| Office Action Summary | Application No. 10/822,255 | Applicant(s) NAY ET AL. | |

DETAILED ACTION

Exhibit 1: Moore et al. '690 Figures 2 and 9

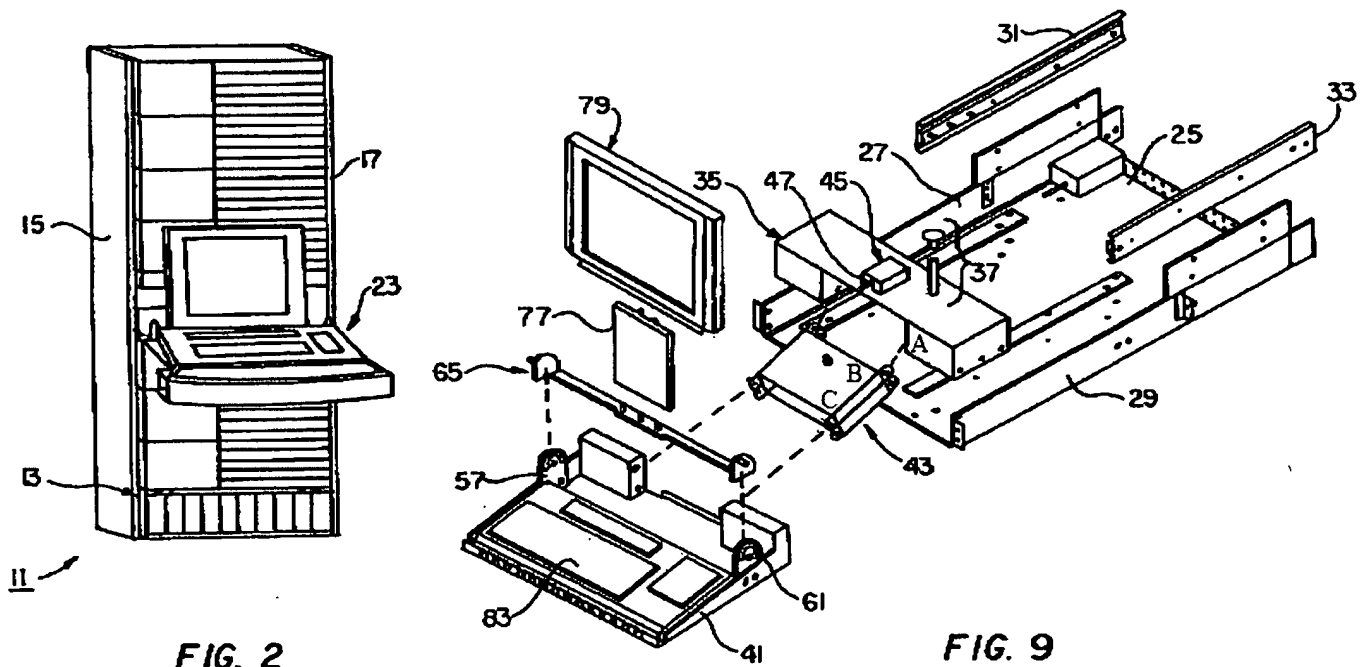
15. Claims 1-20, as best understood, are rejected under 35 U.S.C. 102(b) as being anticipated by Moore et al. (US Patent Number 6201690). Moore (Figures 2, 9-13) discloses a computer terminal bracket (23) adapted for rack mounting and to carry a computer terminal comprising: a keyboard holder (41), wherein the height of the keyboard holder is adjustable in a vertical direction; and a display holder (77), wherein the viewing angle of said display holder is adjustable with respect to a cabinet (13) and keyboard holder.

18. Regarding claim 4, Moore further discloses a first frame (35) movable with respect to a rack (viewed as cabinet 13) whereby a distal edge region (viewed as A in Exhibit 1) of the first frame of the bracket is extendable outwardly from the rack; and a second frame (43) pivotally mounted at its proximal edge region (B) to the distal edge region of the first frame for vertical movement of the keyboard holder and display holder (see Figures 10-13).

19. Regarding claim 5, Moore further discloses the keyboard holder and display holder are pivotally mounted to the second frame at a distal region (C) thereof for angular adjustment of the keyboard holder and display holder.

21. Regarding claims 8 and 14, Moore discloses a cabinet (13) comprising a bracket (23) being adjustably movable outward from the cabinet, and having a user workspace (41 and associated components) configured to be horizontal and perpendicular to a face of the cabinet, said bracket comprising: a first frame (35) vertically fixed and horizontally movable with respect to the cabinet; and a second frame (43) pivotally joined to the first frame with a pivot at the proximal edge (A) of the first frame; and said user workspace pivotally joined to the second frame with a pivot at the proximal edge (C) of the second frame.

Moore et al. '690 Figures 10-13

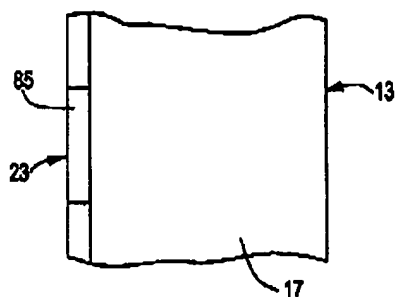
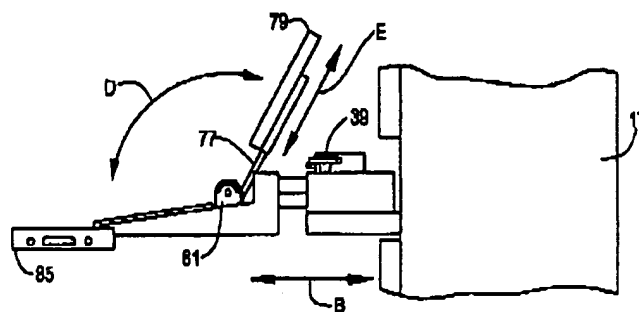
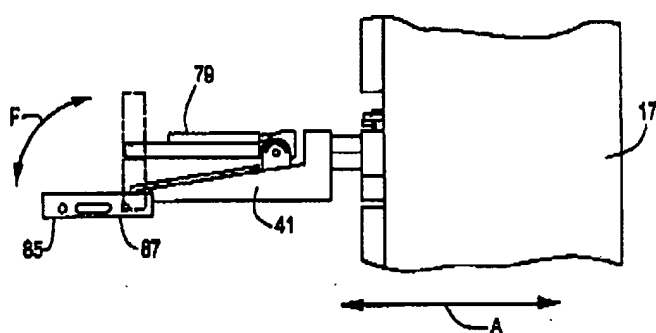
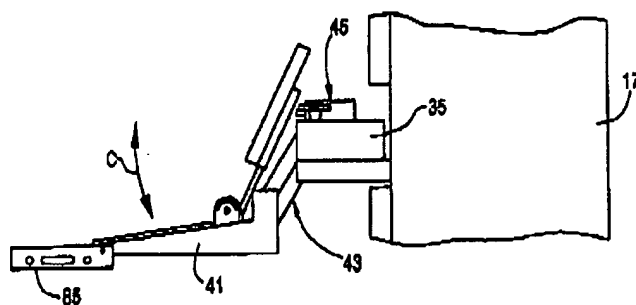
16. Regarding claim 2, Moore further discloses the bracket folds into a single horizontal plane whereby the keyboard holder, display holder, and bracket are coplanar and storable in the cabinet (any number of horizontal planes would pass through all of these elements in their folded position). See Figures 10-12.

Schairbaum '823 Figure 6

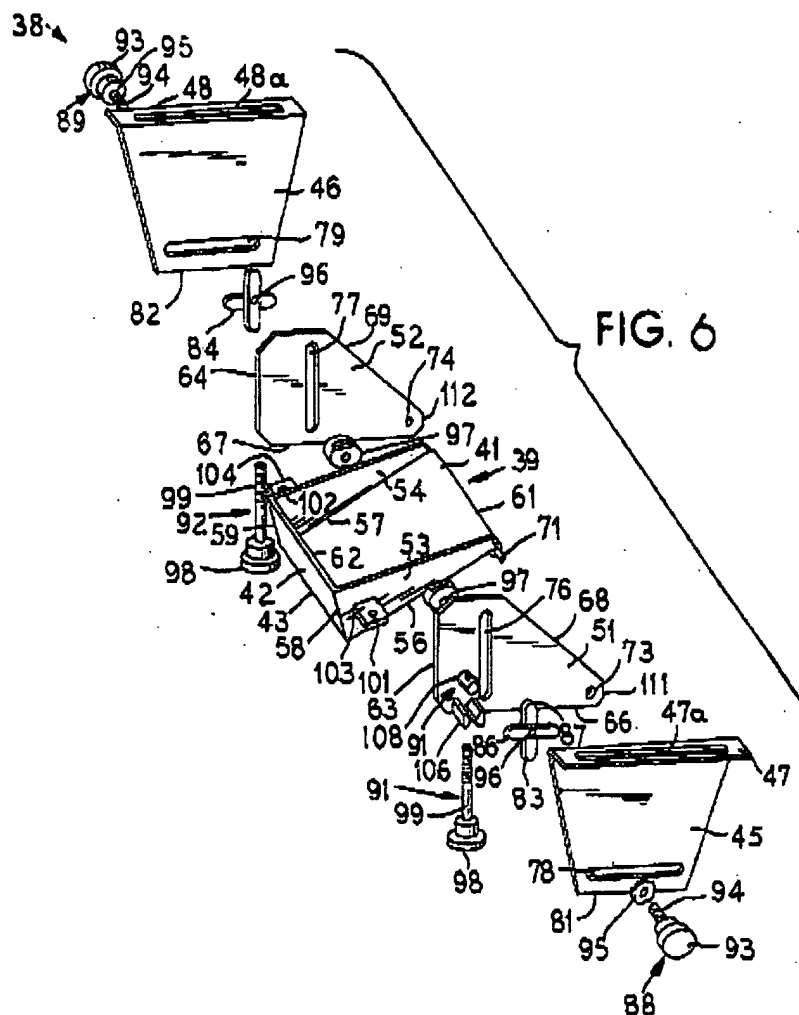
29. Claims 21 and 22 are rejected under 35 U.S.C. 103(a) as being unpatentable over Moore in view of Schairbaum (US Patent Number 5655823). Moore discloses a cabinet as recited in claim 20 but does not disclose a rail or frame with a surface having a low coefficient of sliding friction. Schairbaum (Figure 6) discloses a monitor support

assembly including low sliding friction coefficient slides (83 and 84) for engaging rails (76-79). The slides are preferably made of polypropylene (see column 5 lines 36-39).

Accordingly, it would have been obvious to one of ordinary skill in the art at the time the invention was made to modify Moore's frame to include a low friction surface such as polypropylene as taught by Schairbaum because this would allow the frame to slide more easily on the rail.

Gill et al. '032 Figure 4

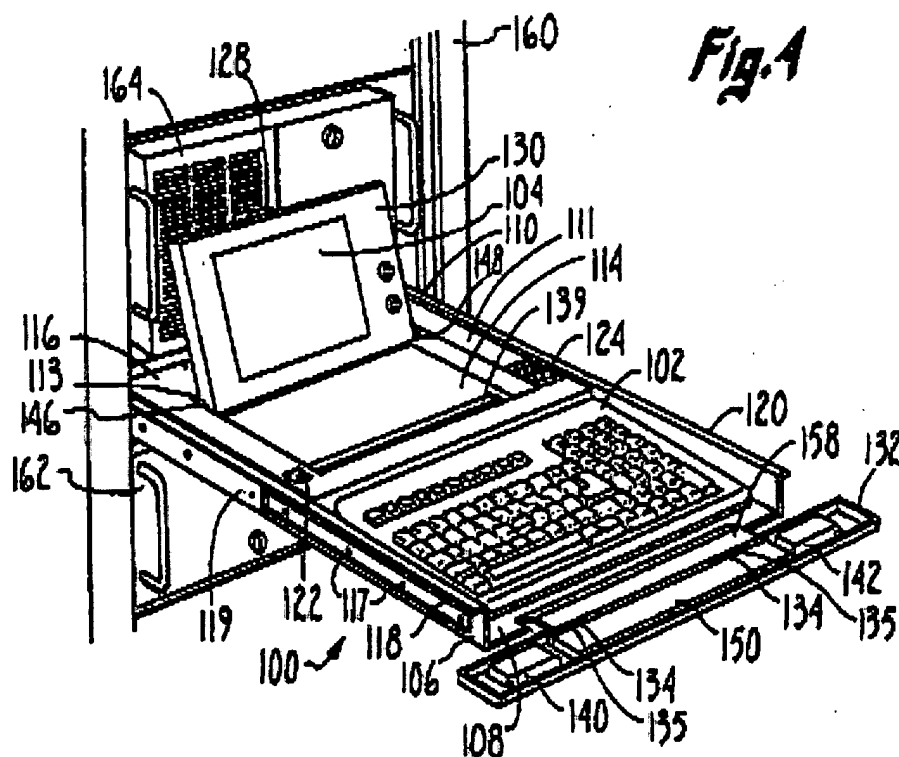
30. Claims 23 and 24 are rejected under 35 U.S.C. 103(a) as being unpatentable over Moore in view of Gill et al. (US Patent Number 5388032). Moore discloses a cabinet as recited in claim 20 but does not disclose a rail or frame comprising a rolling element. Gill (Figure 4) discloses a rack mounted computer terminal including a rail (119) and a frame (118) comprising a rolling element (disclosed as either a wheel or a bearing, see column 8 lines 41-43). Accordingly, it would have been obvious to one of ordinary skill in the art at the time the invention was made to modify Moore's rail or frame to include either a wheel or bearing as taught by Gill because this would allow the frame to slide more easily on the rail.
